UNITED STATES PATENT AND TRADEMARK OFFICE

APPLICATION NO.	FILING DATE	FIRST NAMED INVENTOR	ATTORNEY DOCKET NO.	CONFIRMATION NO.
10/630,210	07/30/2003	Joseph E. Mattingly JR.	AMC.P.US0021	2012
26360	7590	02/21/2006	EXAMINER	
RENNER, KENNER, GREIVE, BOBAK, TAYLOR & WEBER FIRST NATIONAL TOWER FOURTH FLOOR 106 S. MAIN STREET AKRON, OH 44308			COOLEY, CHARLES E	
			ART UNIT	PAPER NUMBER
			1723

Office Action Summary	Application No.	Applicant(s)	
	10/630,210	MATTINGLY, JOSEPH E.	
	Examiner	Art Unit	
	Charles E. Cooley	1723

NON-FINAL OFFICE ACTION

第 1 図

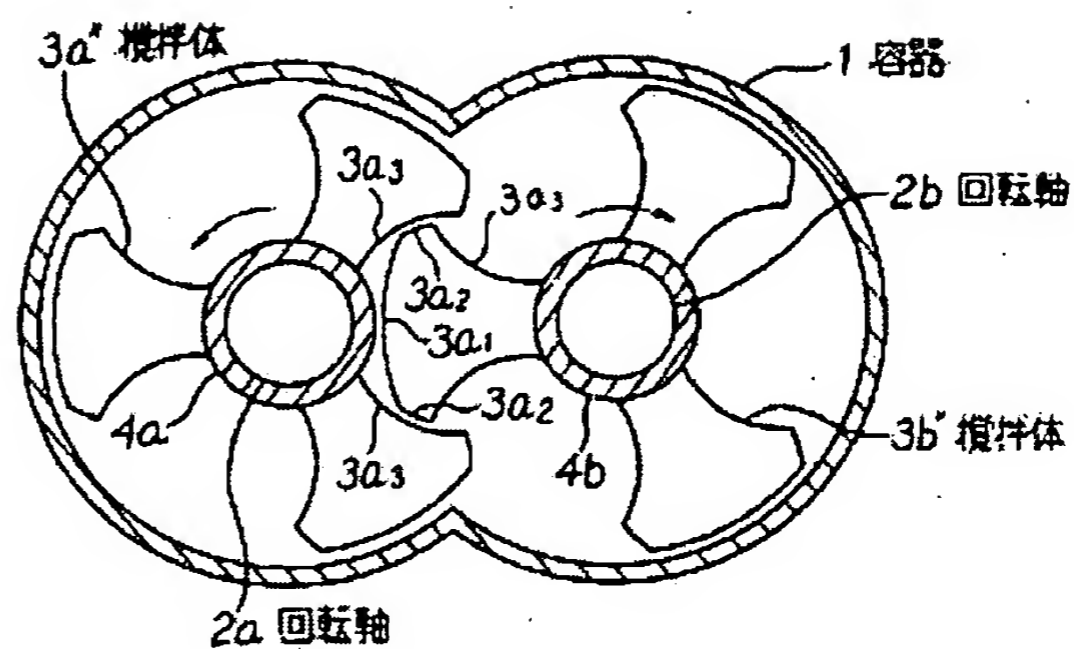
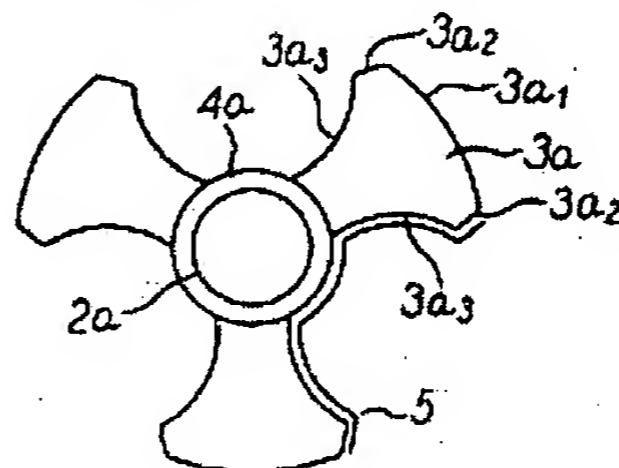
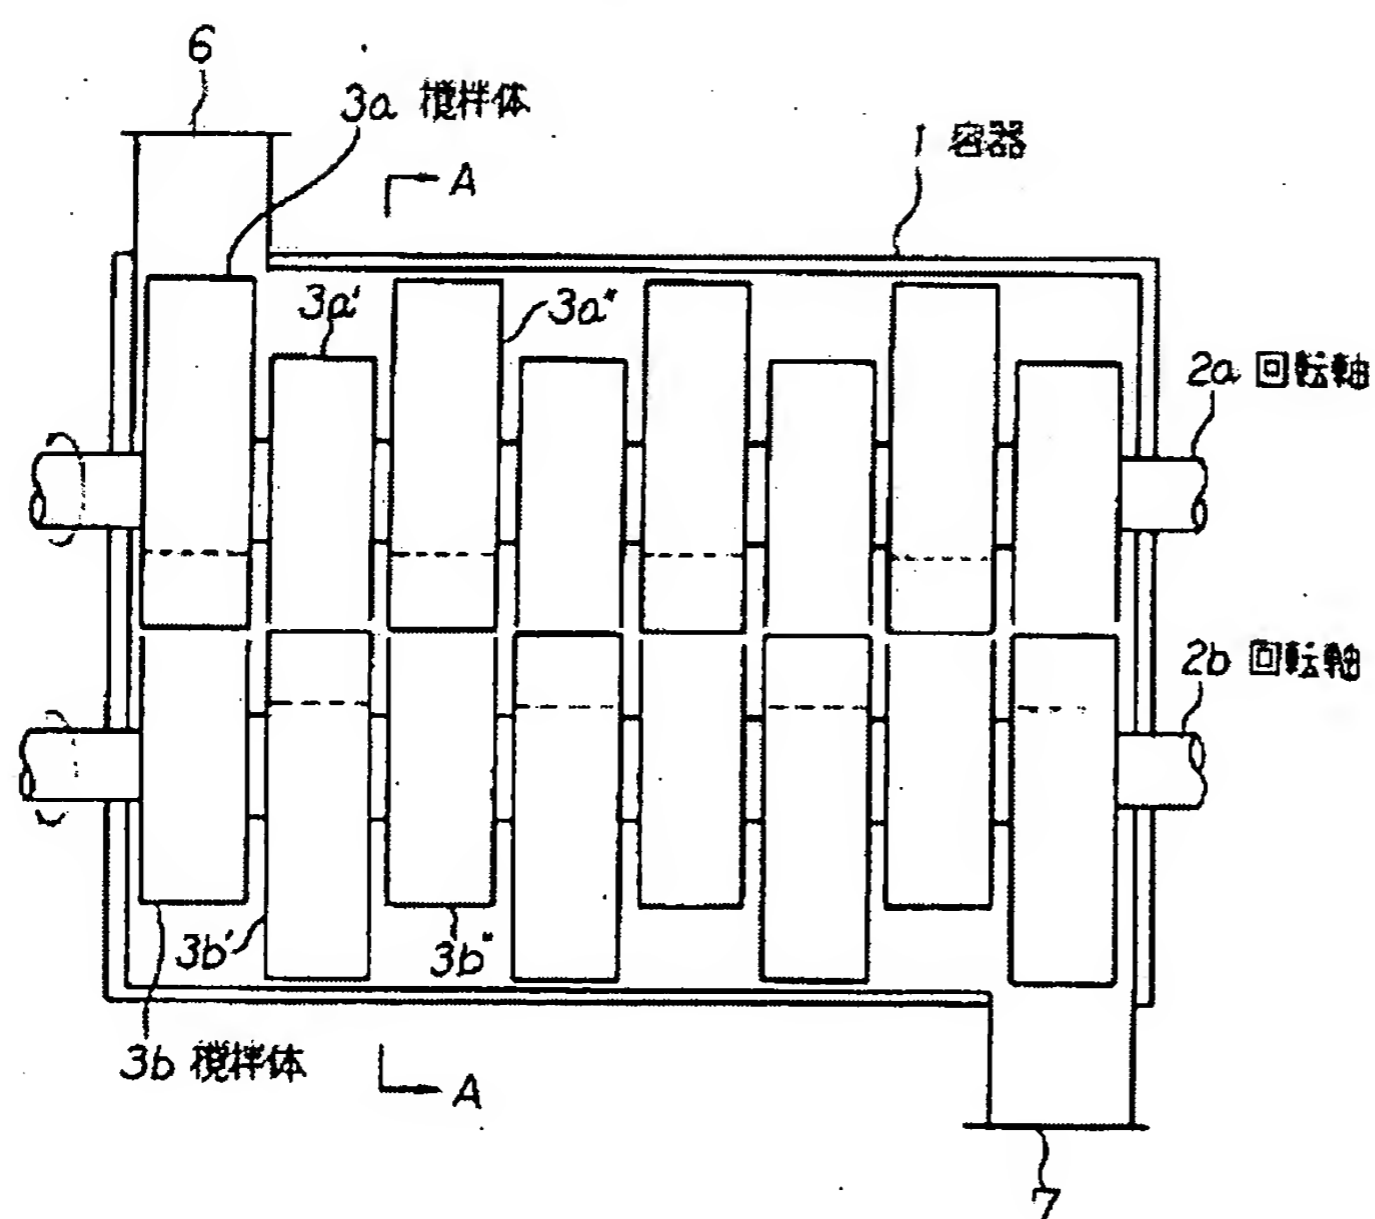
12. Claims 1, 3, 4, 5, 9, 11, 12, 13, 15, 16, 17, 18, and 19 are rejected under 35 U.S.C. 102(b) as being anticipated by JP 4-104827.

JP 4-104827 discloses an element (one or more of members 3a or 3b) as seen in the Figures below comprising one or more lobes extending from a central portion adapted to receive a shaft 2a or 2b; wherein the one or more lobes has an outer periphery ridge and first and second lateral sidewalls, wherein one of said lateral sidewalls of said at least one lobe is concave between said outer periphery ridge and said central portion (as seen in the Figures); wherein the other of said lateral sidewalls on each lobe is concave between said first outer periphery ridge and said central portion (as seen in the Figures); the element may comprise one or more of members 3a or 3b and includes two or three or more lobes as seen in Figs. 1-3; the element constituting a block comprising a plurality of elements (multiple members 3a or 3b), wherein the block includes at least two kneading elements 3a or 3b wherein one of the lateral sidewalls on at least one lobe is concave between said outer periphery ridge and said central portion; wherein the block comprises N number of kneading elements 3a or 3b adjacent to each other (e.g., N number of 3a or 3b - Fig. 1), wherein all the elements have at least one lobe having first and second lateral sidewalls and wherein one of the lateral sidewalls on said at least one lobe is concave between said outer periphery ridge and said central portion; wherein at least the first element (an upstream member 3a or 3b) of the block has at least one lobe having first and second lateral sidewalls and wherein one of the lateral sidewalls on said at least one lobe is concave between said outer periphery ridge and said central portion; wherein at least the last

element (a downstream member 3a or 3b) of the block has at least one lobe having first and second lateral sidewalls and wherein one of the lateral sidewalls on said at least one lobe is concave between said outer periphery ridge and said central portion; wherein at least the first and last elements (an upstream member 3a or 3b and a downstream member 3a or 3b) of the block has at least one lobe having first and second lateral sidewalls and wherein one of the lateral sidewalls on said at least one lobe is concave between said outer periphery ridge and said central portion; wherein the other of said lateral sidewalls on each lobe in the block is concave between said first outer periphery ridge and said central portion (as seen in the Figures).
